CRMC DECISION WORKSHEET

2023-10-090

STATE OF RHODE ISLAND
COASTAL RESOURCES MANAGEMENT COUNCIL
STAFF REPORT TO THE COUNCIL

Water Type/Name:	Type 1, Almy Creek
Freshwater Wetland:	Nonquit Pond
Coastal Feature:	Almy Creek (tidal) and contiguous coastal wetland
Plans Reviewed:	"State Of Rhode Island Department Of Transportation Plan Of Proposed Nonquit Pond Bridge No. 292 Pond Bridge Road Tiverton, RI..." All sheets, dated September 2023, prepared by David J. Elwell PE Pare Corporation

*RIDEM GIS Aerial photography Spring 2023; Existing Conditions

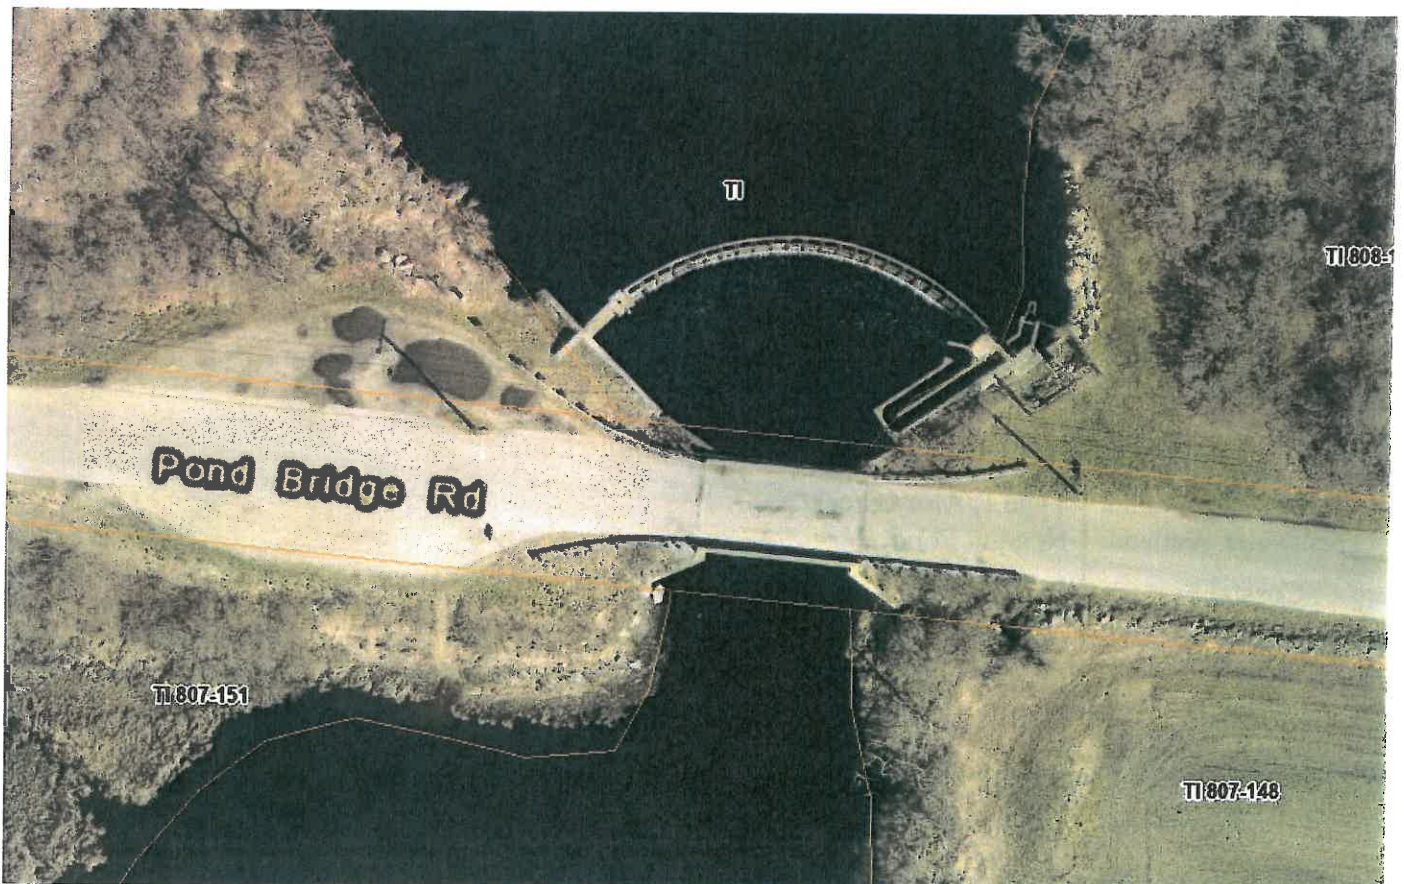
The existing bridge carries one lane of traffic in each direction. The current width out-to-out is appx 22'-6". The curb-to-curb measures 20'. No sidewalks or bike lanes are present, nor could any be added with current dimensions.
